16469	Pit, Closed-Loop System, Below-Grade Tank, or Proposed Alternative Method Permit or Closure Plan Application
	Type of action:  Permit of a pit, closed-loop system, below-grade tank, or proposed alternative method  Closure of a pit, closed-loop system, below-grade tank, or proposed alternative method  Modification to an existing permit  Closure plan only submitted for an existing permitted or non-permitted pit, closed-loop system, below-grade tank, or proposed alternative method
Instr	uctions: Please submit one application (Form C-144) per individual pit, closed-loop system, below-grade tank or alternative request
Please be advise	ed that approval of this request does not relieve the operator of liability should operations result in pollution of surface water, ground water or the

Operator: BP AMERICA PRODUCTION COMPANY OGRID #: 778					
Address: 200 Energy Court, Farmington, NM 87401					
Facility or well name: MOORE A 003A					
API Number: 3004521862 OCD Permit Number:					
U/L or Qtr/Qtr  Section 4.0 Township 30.0N Range 08W County: San Juan County					
Center of Proposed Design: Latitude <u>36.838095</u> Longitude <u>-107.67493</u> NAD: □1927 × 1983					
Surface Owner: ▼ F

# **GROUND WATER LESS THAN 50 FT.**

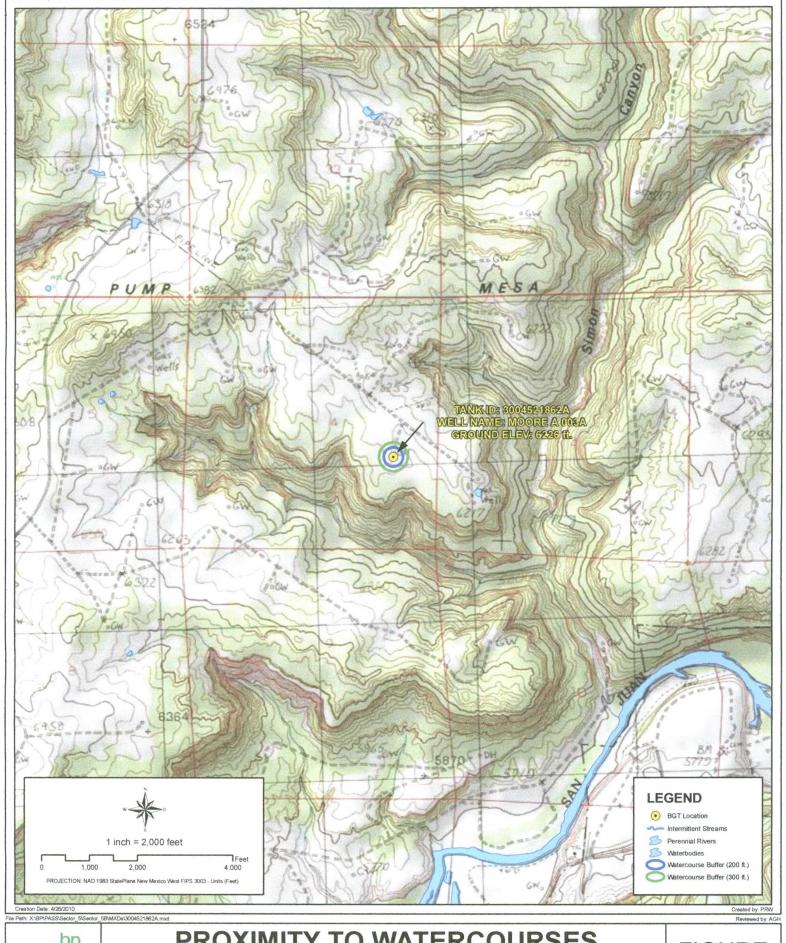
- BP will close the BGT to the most stringent standard GW ≤ 50'

BP registration pack did not include conclusive Ground water information, BP can submit additional ground water information if warranted.
